UNITED STATES PATENT AND TRADEMARK OFFICE

APPLICATION NO.	FILING DATE	FIRST NAMED INVENTOR	ATTORNEY DOCKET NO.	CONFIRMATION NO.
10/650,416	08/29/2003	David Edwin Zapp	DEZ 001 P2	6570
7590	03/13/2006		EXAMINER	
Patrick P. Phillips Kremblas, Foster, Phillips & Pollick 7632 Slate Ridge Boulevard Reynoldsburg, OH 43068			PRICE, CARL D	
			ART UNIT	PAPER NUMBER
			3749

Office Action Summary	Application No. 10/650,416	Applicant(s) ZAPP, DAVID EDWIN	
	Examiner CARL D. PRICE	Art Unit 3749

Applicant - David E. Zapp
Serial - 10/650,416
Title - Charcoal Fire Starter and Cooking Device
Docket No. DEZ 001 P2
Sheet 2 of 4

FIG. 3

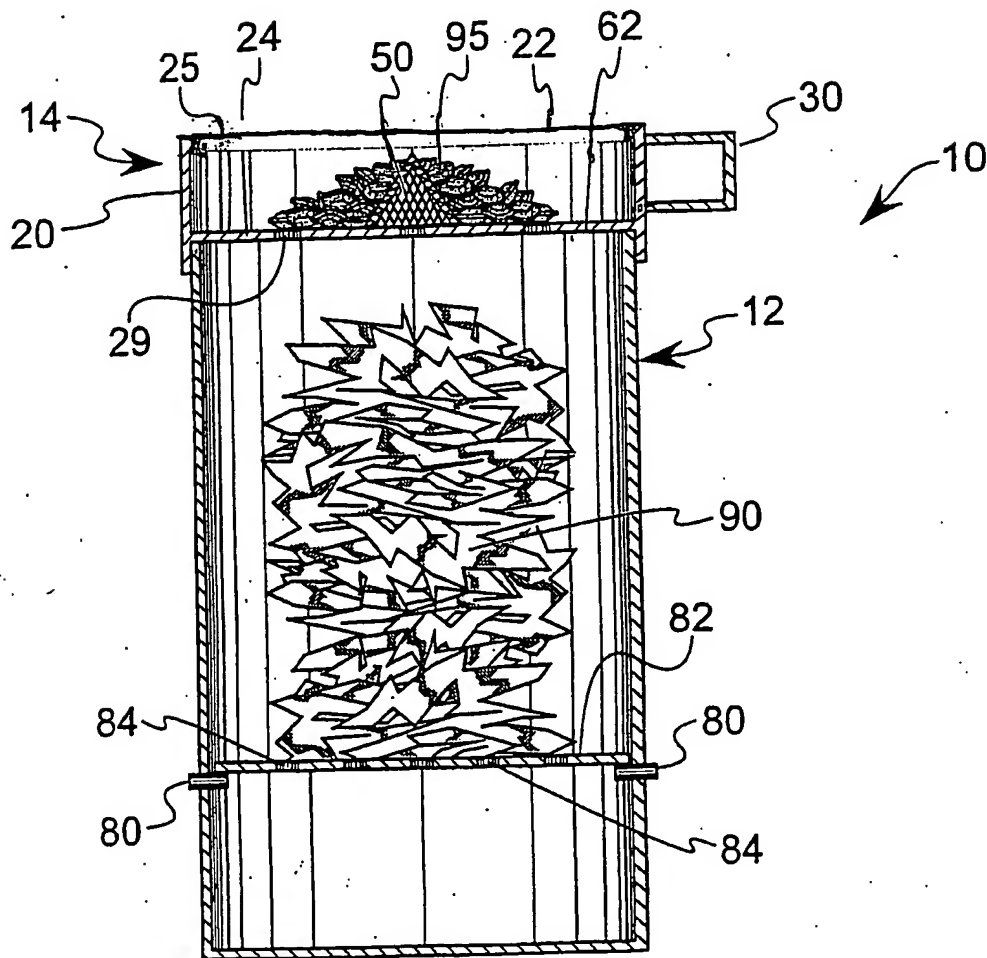
Approved
2/23/06
